**Report: Issue Data**  
**Function: Test, Adjust, & Balance**  
**Date: 12/04/2025**  
**Completed By: National TAB**

**PROJECT**  
**CW 8950 - Mr Cooper (Coppell, TX)**

## Issue List

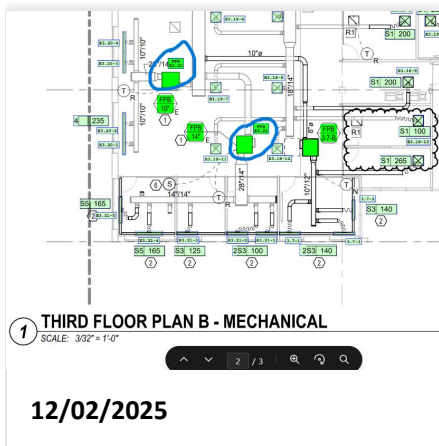
**Issue Name :** FPB-E3.20 Control Issue  
**Description :** FPB-E3.20(FPB3-46 on controls graphics) does not pull up the right box when opened on control graphics. Box is labeled as FPB3-46 on control graphics, however it opens box FPB3-47. The only way to access the correct box is to go through the RTU matrix page.  
**Created By :** National TAB                      **Assigned To :** National TAB - Stephan Gabbert  
**Status :** Open  
**Priority :** InfoOnly                                      **Asset Tag :**  
**Originated Date :** 12/02/2025 - Bayley Morvant - National TAB

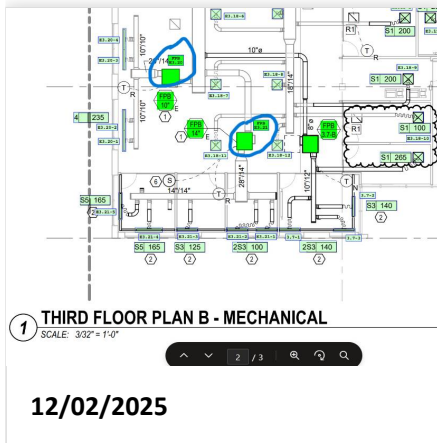
**Issue Name :** FPB-E3.21 Control Issue  
**Description :** FPB-E3.21(FPB3-45 on controls graphics) does not pull up the right box when opened on control graphics. Box is labeled as FPB3-45 on control graphics, however it opens box FPB2-18. The only way to access the correct box is to go through the RTU matrix page.

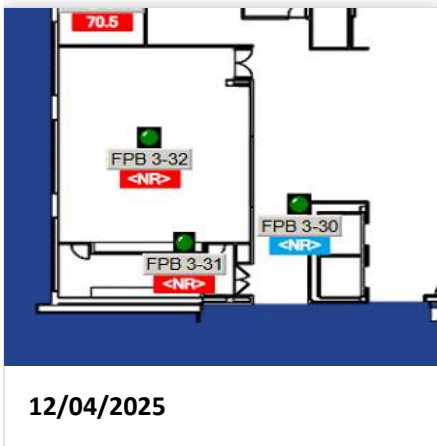
**Issue Name :** FPBE3.1 Showing "NR" on Controls  
**Description :** FPBE3.1 is showing "NR" on controls. Unit is not operational. (Box labeled as FPB3-32 on controls)  
**Created By :** National TAB                      **Assigned To :** National TAB - Stephan Gabbert  
**Status :** Open  
**Priority :** Urgent                                      **Asset Tag :**  
**Originated Date :** 12/04/2025 - Bayley Morvant - National TAB

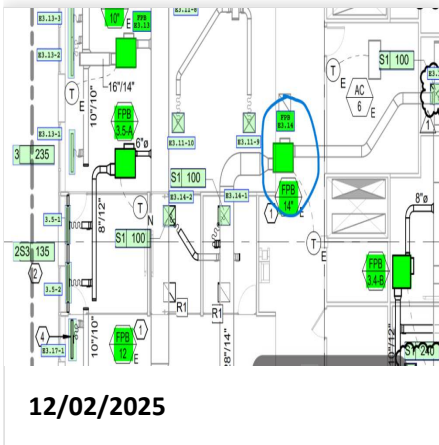
**Issue Name :** FPBE3.14 FAN NOT OPERATIONAL  
**Description :** EXISTING BOX FPBE3.14 FAN IS NOT OPERATIONAL. UNABLE TO BALANCE FAN TO DESIGN CFM. (BOX IS LABELED AS FPB3-48 ON CONTROLS GRAPHICS)  
**Created By :** National TAB                      **Assigned To :** National TAB - Stephan Gabbert  
**Status :** Open  
**Priority :** Urgent                                      **Asset Tag :**  
**Originated Date :** 12/02/2025 - Bayley Morvant - National TAB

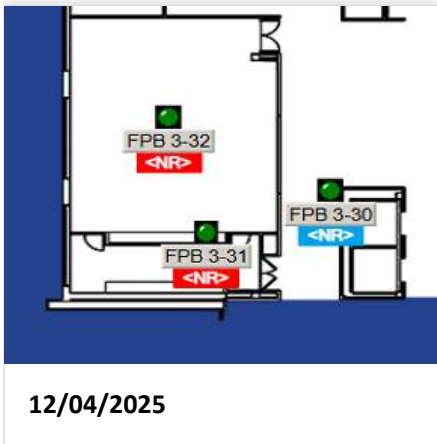
**Issue Name :** FPBE3.2 Showing "NR" on Controls  
**Description :** FPBE3.2 is showing "NR" on controls. Box is not operational. (Box labeled as FPB3-31 on controls)  
**Created By :** National TAB                      **Assigned To :** National TAB - Stephan Gabbert  
**Status :** Open  
**Priority :** Urgent                                      **Asset Tag :**  
**Originated Date :** 12/04/2025 - Bayley Morvant - National TAB

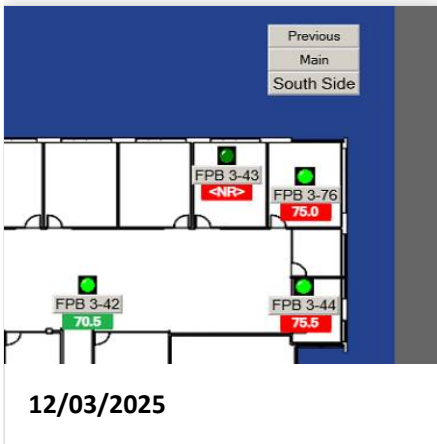
**Issue Name :** FPBE3.23 Showing "NR" on Controls  
**Description :** FPBE3.23 is showing "NR" on controls. Unable to control box to calibrate and balance. (Controls name for thie box is FPB3-43)  
**Created By :** National TAB                      **Assigned To :** National TAB - Stephan Gabbert  
**Status :** Open  
**Priority :** **Urgent**                                      **Asset Tag :**  
**Originated Date :** 12/03/2025 - Bayley Morvant - National TAB

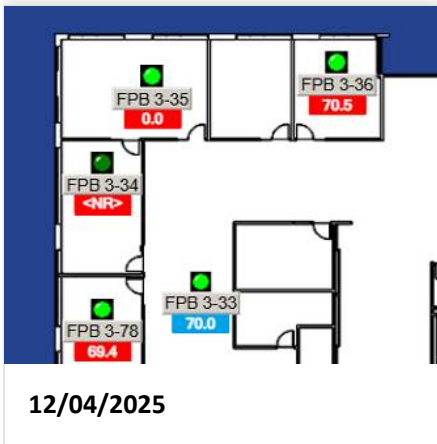
**Issue Name :** FPBE3.4 Showing "NR" on Controls  
**Description :** FPBE3.4 is showing "NR" on controls and is not operational. (Box labeled as FPB3-34 on controls graphics)  
**Created By :** National TAB                      **Assigned To :** National TAB - Stephan Gabbert  
**Status :** Open  
**Priority :** Urgent                                      **Asset Tag :**  
**Originated Date :** 12/04/2025 - Bayley Morvant - National TAB

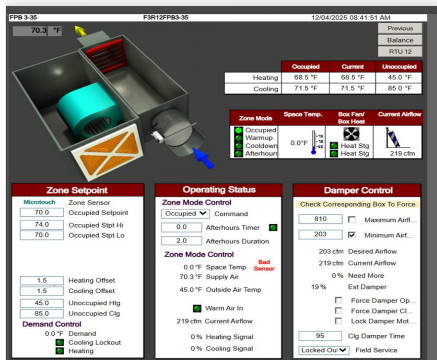
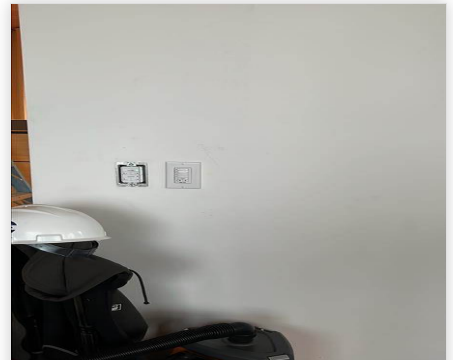
**Issue Name :** FPBE3.5 Thermostat not Mounted  
**Description :** FPBE3.5 thermostat not mounted during time of testing. Unit was able to be calibrated and balanced, however, due to the thermostat not being hooked up heat and fan operation were unable to be checked and balanced. Once thermostat is mounted and hooked up heat and fan can be checked and balanced. (Box is labeled as FPB3-35 on controls)  
**Created By :** National TAB **Assigned To :** National TAB - Stephan Gabbert  
**Status :** Open  
**Priority :** Urgent **Asset Tag :**  
**Originated Date :** 12/04/2025 - Bayley Morvant - National TAB
